# Oakdale West Estate Stage 3 Development

Construction, fitout, and operation of warehouses 2A, 2C, and 2D

State Significant Development Assessment

SSD-9794683

**Figure 8 | Originally Proposed Buildings 2C and 2D Layout denoting the shared driveway**

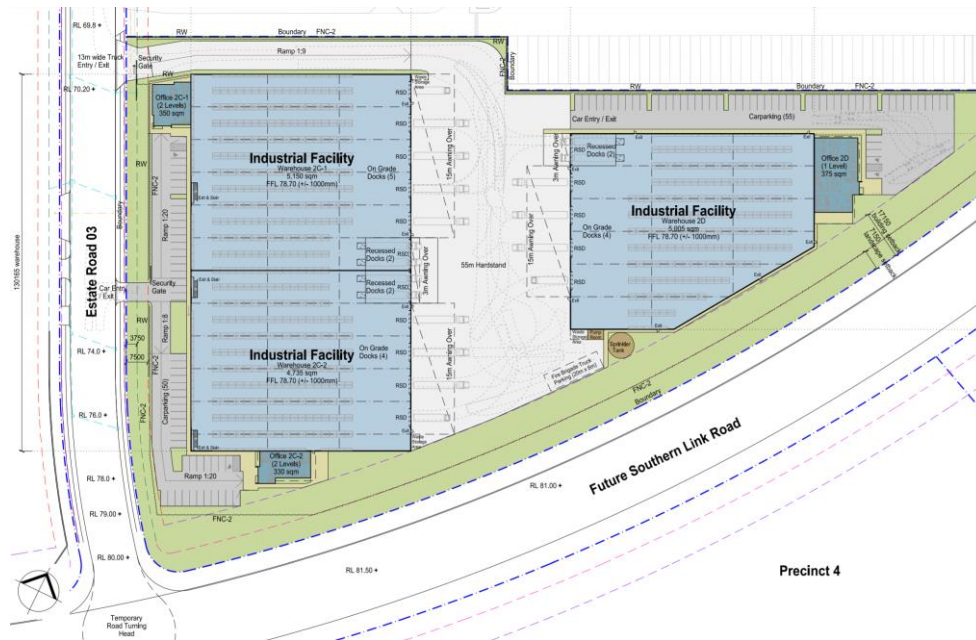
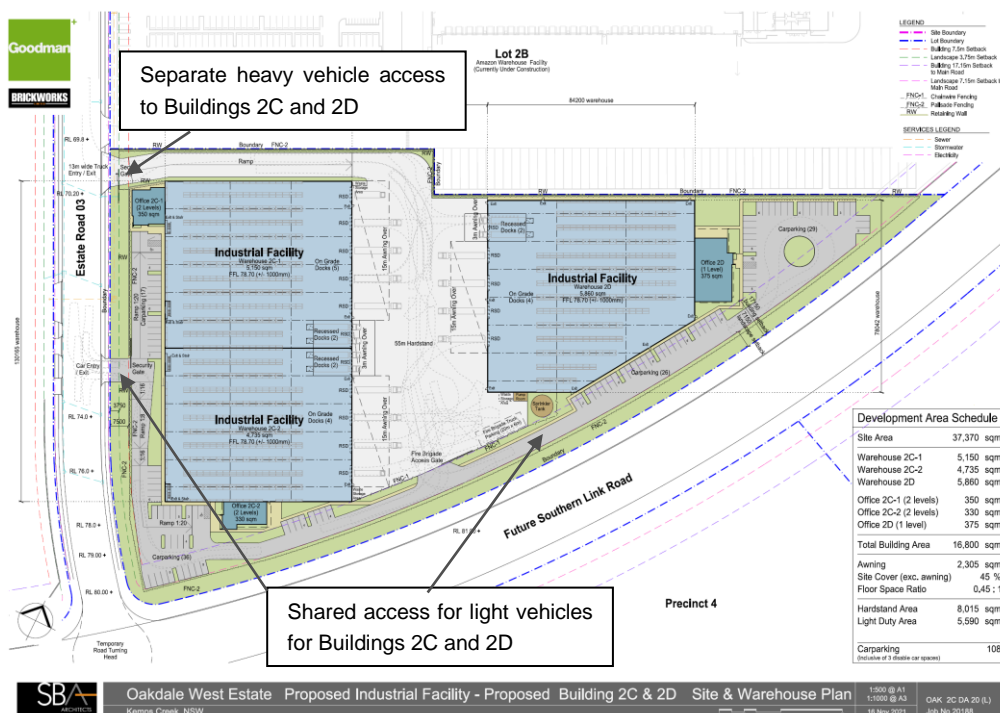
The Applicant initially proposed a shared driveway for light vehicles accessing Building 2D and heavy vehicles accessing the loading docks at Buildings 2C and 2D (see **Figure 8**). The Department, Council and TfNSW raised concerns about the traffic safety and potential conflicts of movements between light and heavy vehicles using the same access. The Applicant responded to the traffic safety concerns by providing a separate light vehicle driveway running along the SLR frontage serving Buildings 2C and 2D car parks. The driveway to the north of Building 2C would be used by trucks only (see **Figure 9**).

Council reviewed the amended design and made comments on driveway design, compliance with Australian Standards, and requested the Applicant provide a swept path diagram for a 26m B-Double turning left out of the Buildings 2C and 2D heavy vehicle driveway onto Emporium Avenue (Estate Road 3).

TfNSW recommended that the light vehicle access for Buildings 2C and 2D be located further northwest (away from the future signals at the SLR) or the Applicant demonstrate that there would be no disruption to the future signalised intersection.

The Applicant responded that the maximum queue length at Emporium Avenue and the future SLR intersection during peak hours would be approximately 61 m. The proposed light vehicle driveway is approximately 100 m from the intersection with the future SLR, providing sufficient queuing capacity between the driveway and the future intersection.
